Pre-shipment Inspection Report

Report #: PSI20230921&22-R2309133838

General Information:	
Client name	XXX
Product name	Alum Box
Item	HP-1,HP-2,HP-3,HP-4,HP-5,HP-6,HP-7,HP-8
PO#	22003978
Ordered quantity(Lot size)	266pcs
Inspection Date	September 21&22, 2023
Arrival time	9:30 AM (21th)
Departure time	16:40 PM (22th)
Supplier name	XXX
Factory name	XXX
Inspection location	XXX

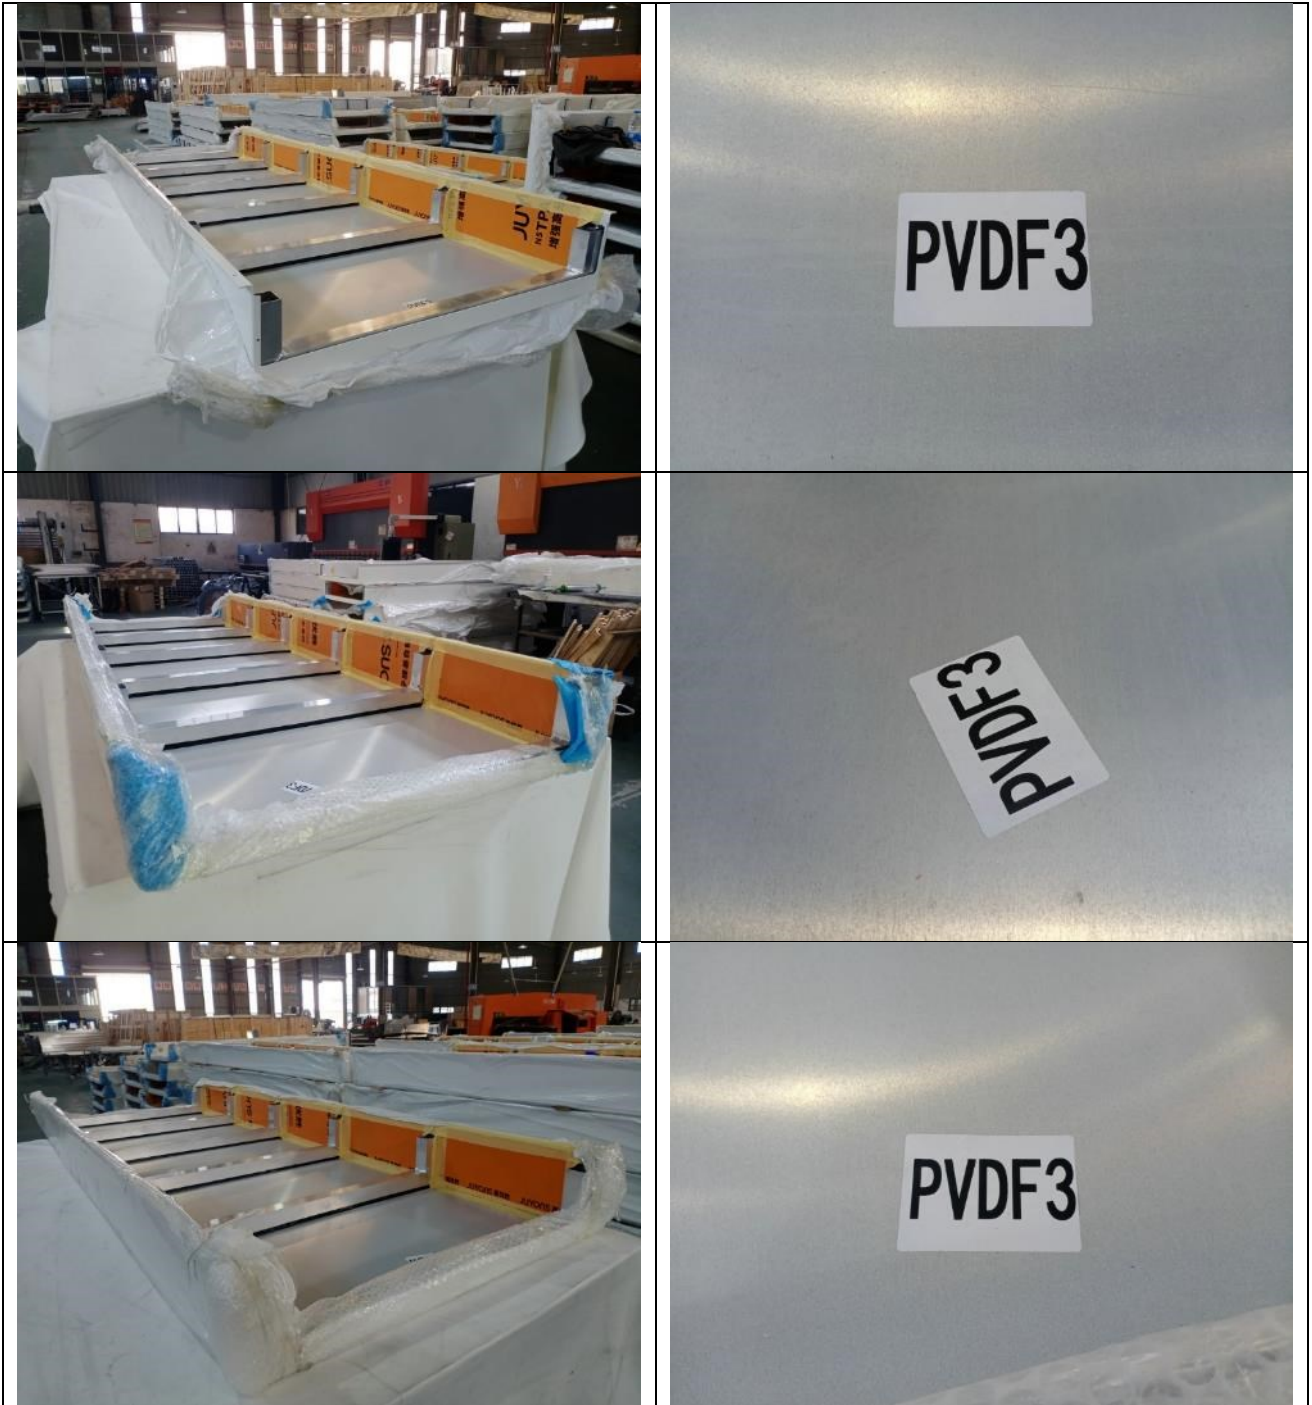
1. The material of which the boxes are made of is – aluminum alloy 5052H32 3 mm. thickness

2. The coloring will be applied in 3 coats (PVDF3) 40>32 μ m thickness

3. PVDF3 seal is printed inside the box

4.As per the client requirement, The finish of the inner part of the boxes should be passivation10µm thickness, but factory missing this process.

5. Only when the inspector arrives at the factory, the products have all completed the installation and reinforcement of the sound insulation film. The factory uses tape to stick all the edges together.

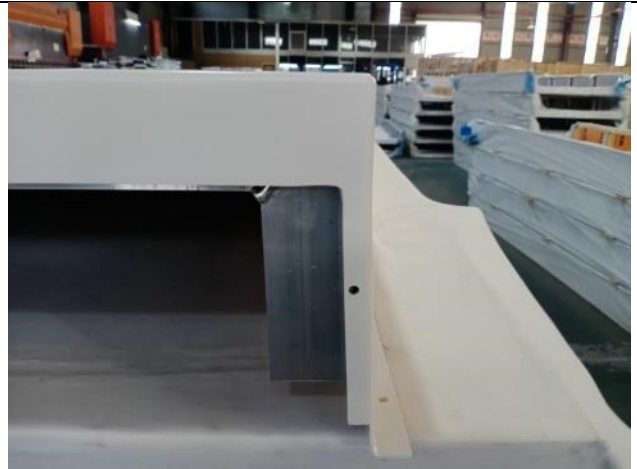
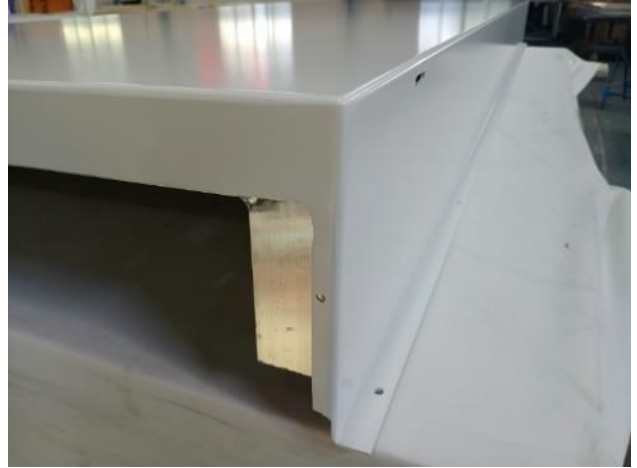
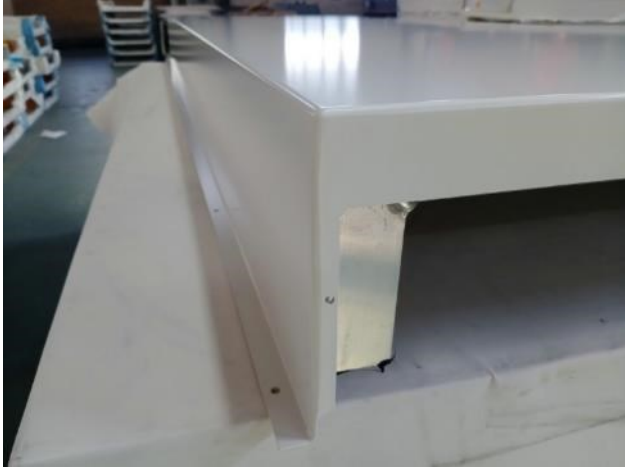
7. Welding thickness test, 4mm ~5mm

8. The reinforcement in the middle were welding from 3 sides, the welding was done with gap
